GRCA Agency Review Document Book

GRCA Agency Review Document Book Index

**RE: Application for Zoning By-Law Amendment
8352 Highway 7
Part lot 1, Concession 6, Township of Guelph/Eramosa
634745 Ontario Limited / James Dick Construction Limited**

**Re: Response to GRCA comments regarding Hidden Quarry
Guelph-Eramosa File ZBA09/2012
Cumulative Effects Assessment Issues**

Figure C6: Northwest Wetland Hydrograph

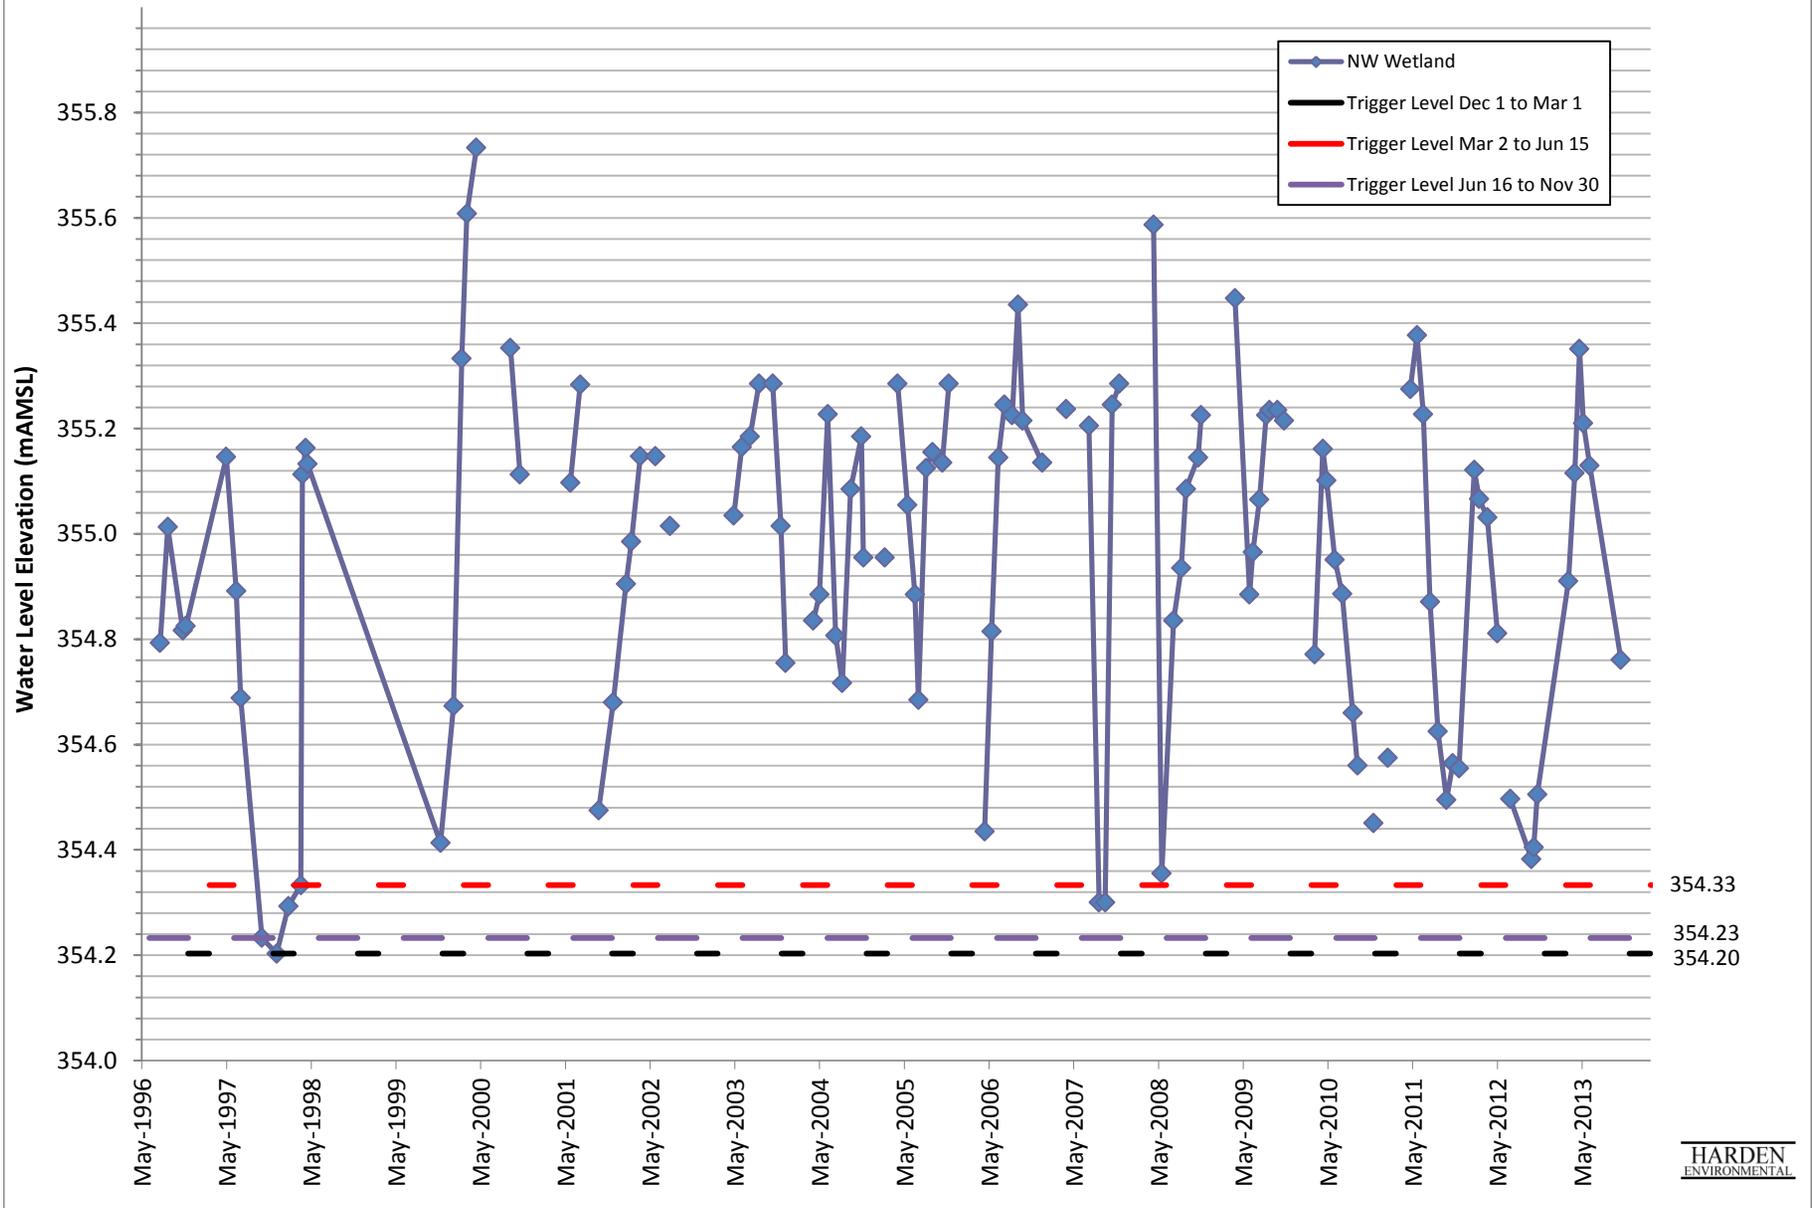
A warning level is established 0.15 metres higher than the trigger level. The warning and trigger levels relative to historical water levels are shown on Figure C6.
